**Date:** August 16, 2019  
**To:** Planning Board  
**From:** Lincoln Daley, Community Development Director  
Kellie Shamel, Town Planner  
**Subject:** SD2019-08 - Richard Keogh, Tax Map 23, Lot 2, 118 Amherst Street. Major Subdivision Application to subdivide the subject parcel into eight (8) total lots, the construction of an 800 linear foot subdivision roadway, related drainage/stormwater improvements, and offsite improvements.

Re: Keogh Subdivision – Tax Map Lot 23-2, #118 Amherst Street

**SUBDIVISION PLAN**  
 LAND OF:  
**RICHARD N. KEOGH**  
 TAX MAP 23 LOT 2  
 MILFORD, NEW HAMPSHIRE  
 SCALE: 1" = 60' MAY 28, 2019

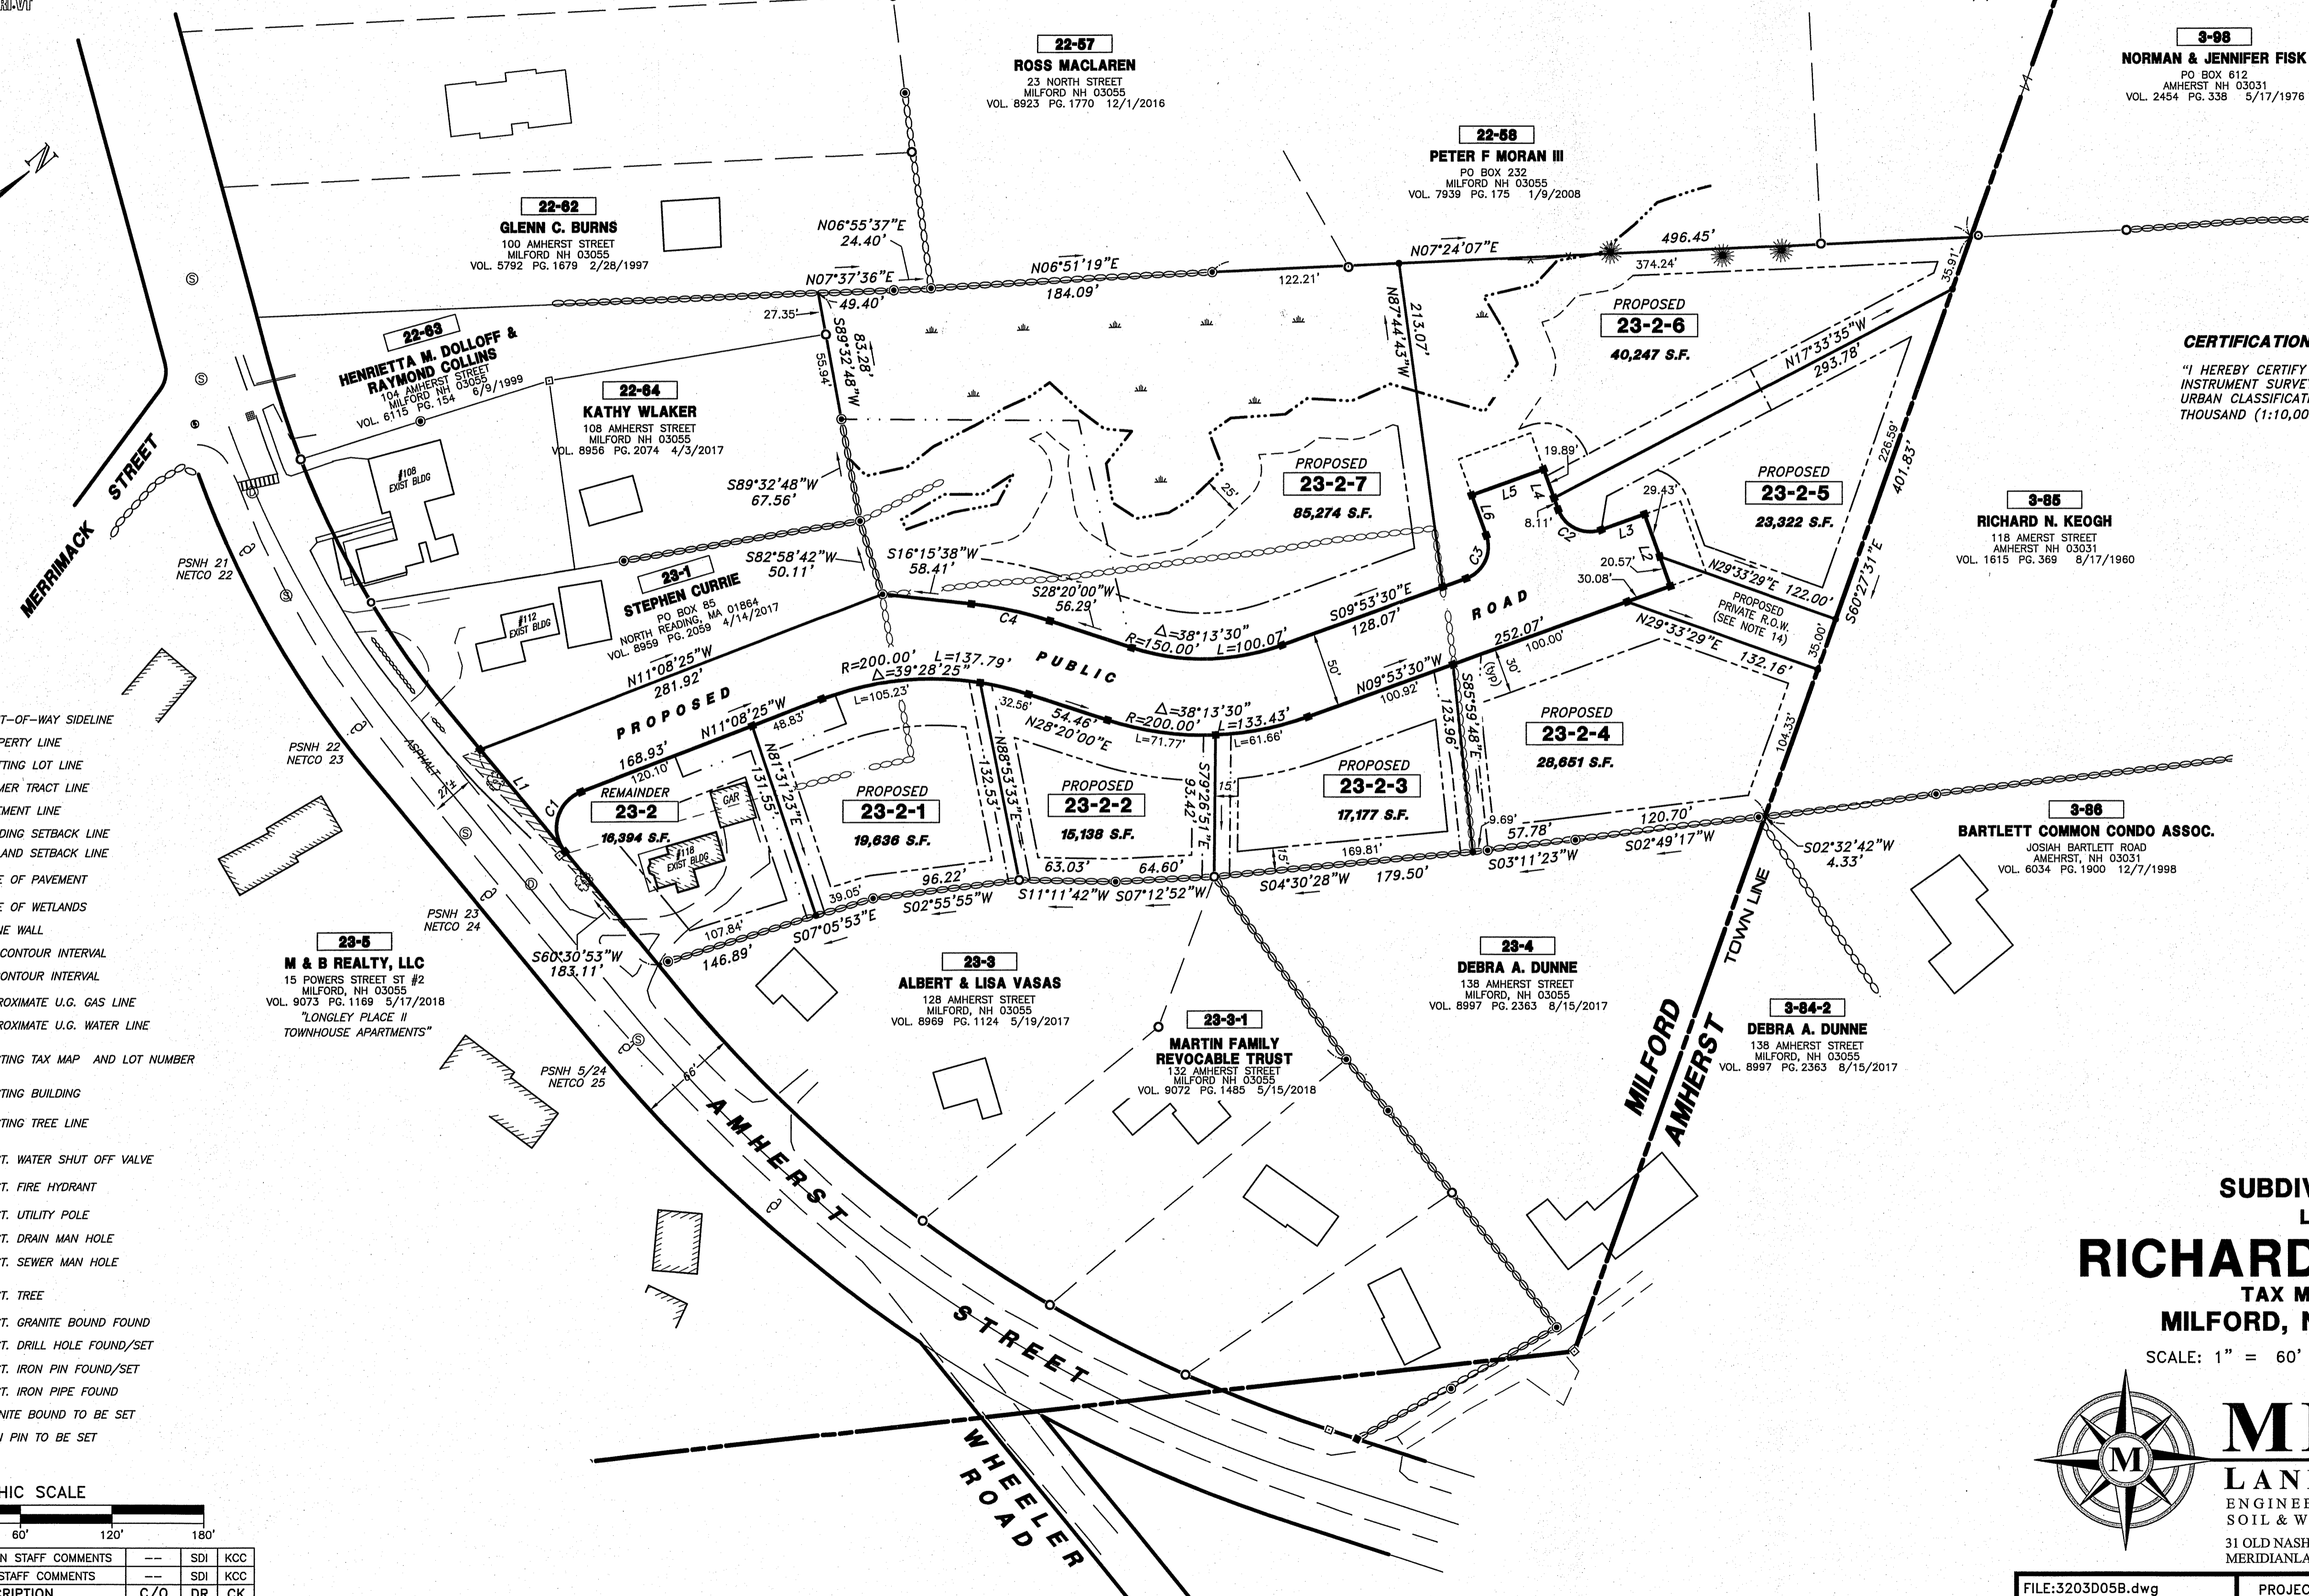
4. Sheet 3 Subdivision Plan, Drainage Easement. Please provide the legal description and limitations for the proposed drainage easement to the Community Development Office for review and approval.

5. Sheet, Subdivision Plan, Driveway Easement. Please provide the legal description and limitations for the proposed driveway easement to the Community Development Office for review and approval.

6. Sheet 3, Subdivision Plan. Both the Building Setback Line and wetland buffer line have the same labeling. Please revise the plan set by delineating the building setback line and wetland buffer line. Further, please revise the plan by showing wetland buffer delineation.

***Partially Addressed.** The plans have been updated to include the approximate dimensions of the drainage easement areas. The Applicant will be required to submit the legal descriptions and restrictions for each proposed drainage easement to the Community Development Office for review and approval.*

***Partially Addressed.** The plans have been updated to include the approximate dimensions of the shared driveway easement. The Applicant will be required to submit the legal descriptions and restrictions said easement to the Community Development Office for review and approval.*

***Partially Addressed.** Please revise the plan to delineate the 25' wetland buffer area for areas between the proposed lots 23-2-7 and 23-2-6. In addition, revise the Legend by changing "Wetland Setback Line" to "Wetland Buffer".*

**P-5**  
 SHEET

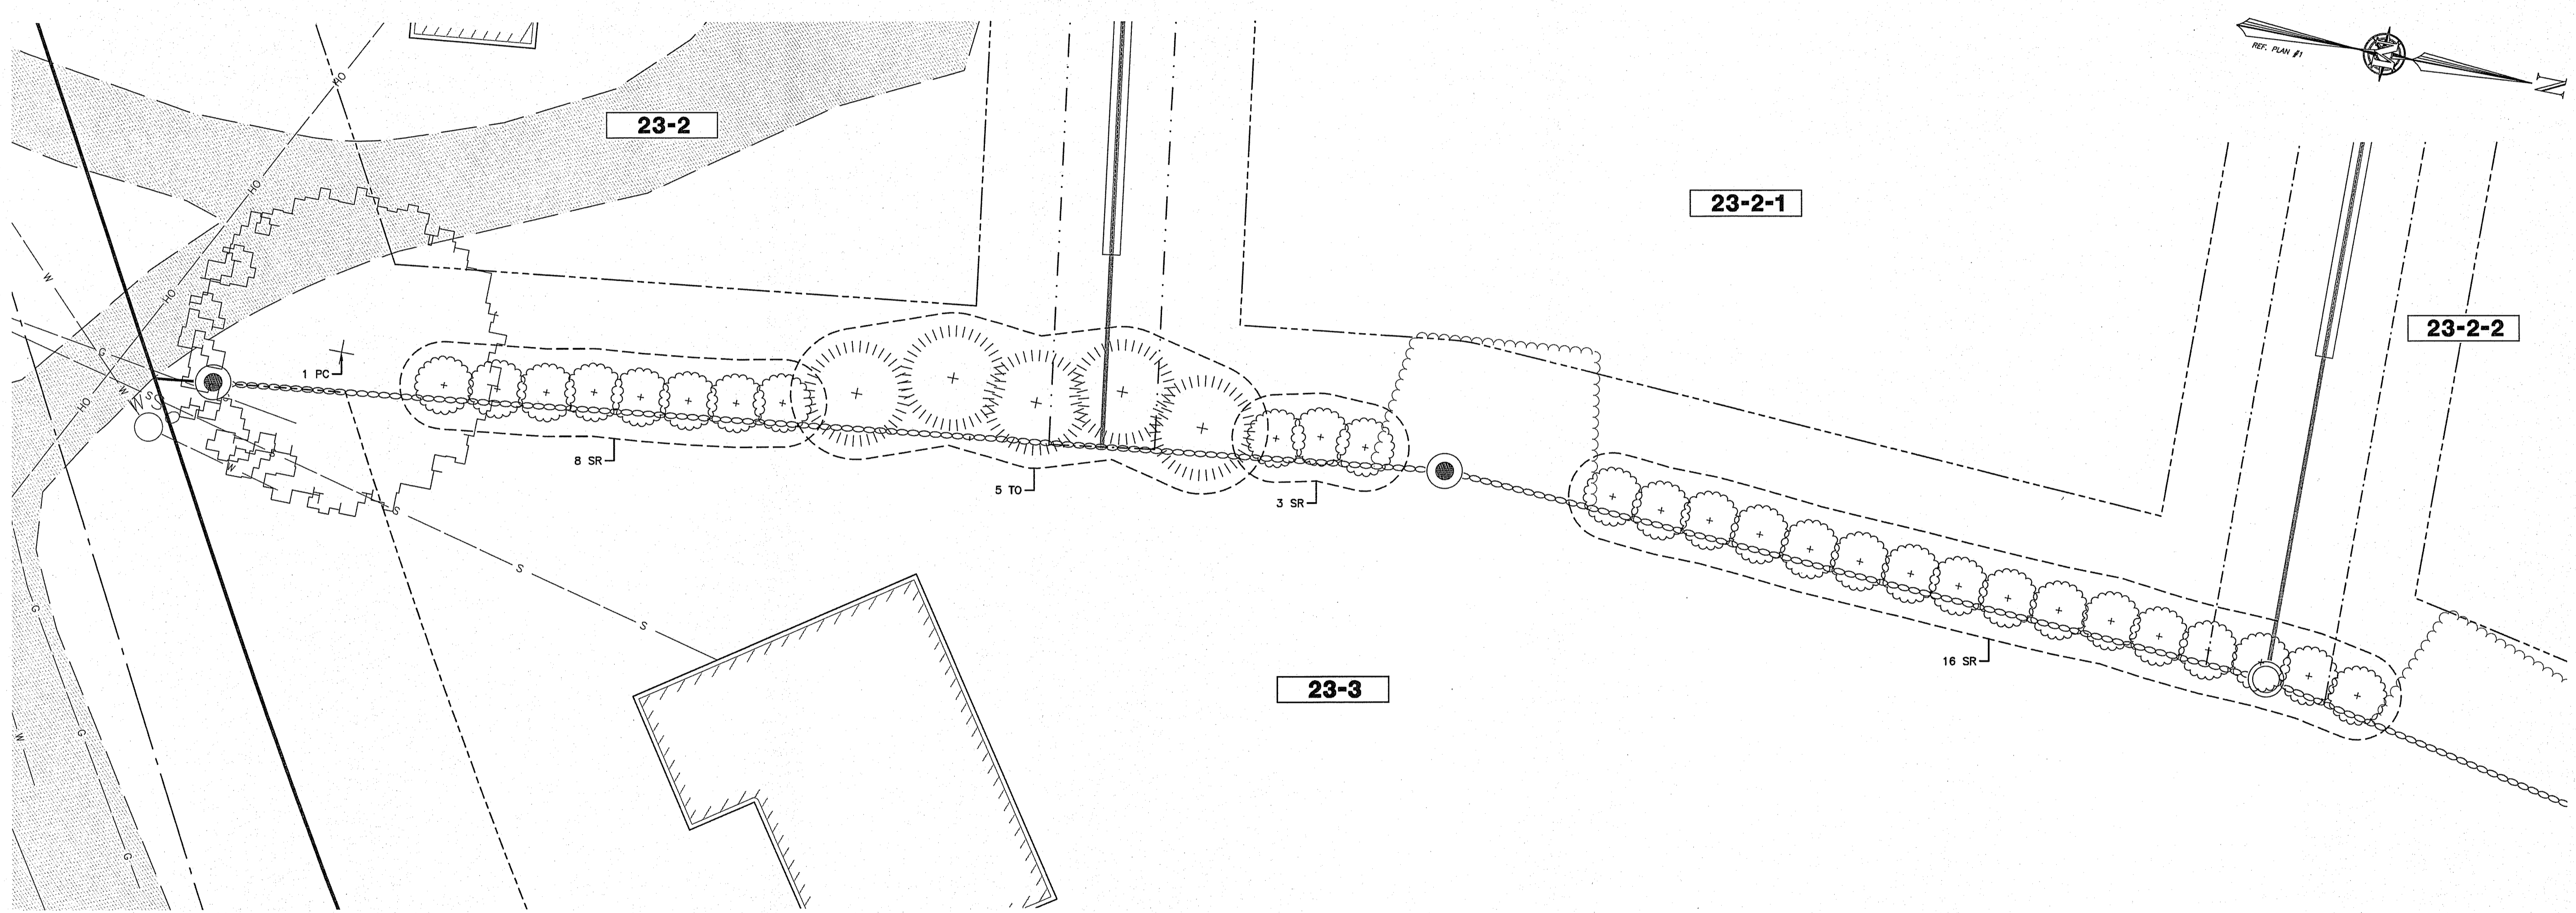
13. General Comment, Sheet P-5. Please revise the sheet to include the approximate finish grade elevations for each proposed house.
  14. Drainage Easement. Based on KV Partners review comments and comment from DPW it is understood that the swales along the lot lines are not to be the responsibility of the Town and therefore should not be included in the easement. Given this information, the responsibility of maintain the swales would fall to the property owners within the subdivision. This would require the formation of a HOA and thus legal documents will need to be drafted and submitted to the Town for review and approval.

**SIDEWALK - ASPHALT**

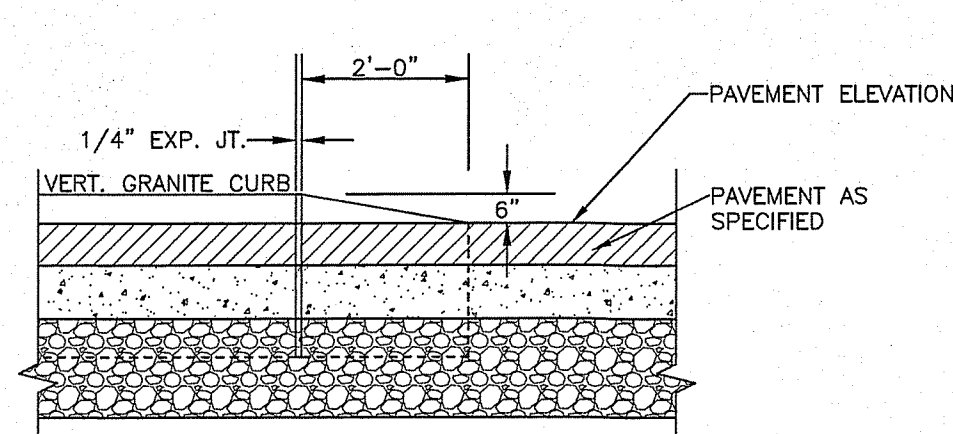
- greater than 100,000 square feet). If yes, please provide the Office of Community Development with a copy of said submittal.
8. Sheet D-1, Sidewalk Detail. Please refer to the Dept. of Public Works, Infrastructure Design, Construction & Administration Standards regarding the engineering and construction of the sidewalk along Amherst Street. *Addressed.*
